SB-10045304-3445

Title: Wrong Bolts in Some 5000 and 9000 models with Horton Fan Hubs

Applies To: ALL 5000i and 9400is

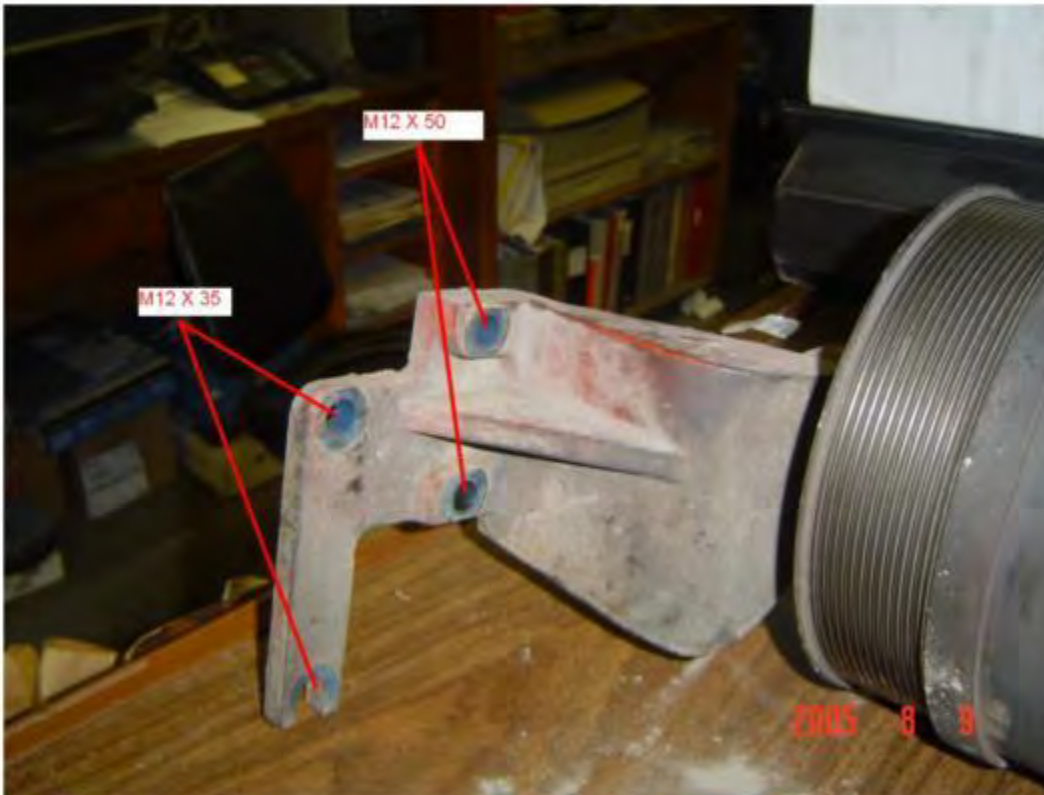
Some 5000i and 9400i models with Horton fan hubs were built with M12 X 40 fan hub mounting bolts in all four positions. While performing the [AFC 05903](#) on all 5000i and 9400i models with Horton fan hubs use kit number **8000859R91** which contains two M12 X 35 and two M12 X 50 mounting bolts. The bolts must be installed in the positions indicated below and tightened to 80-100 lb-ft.
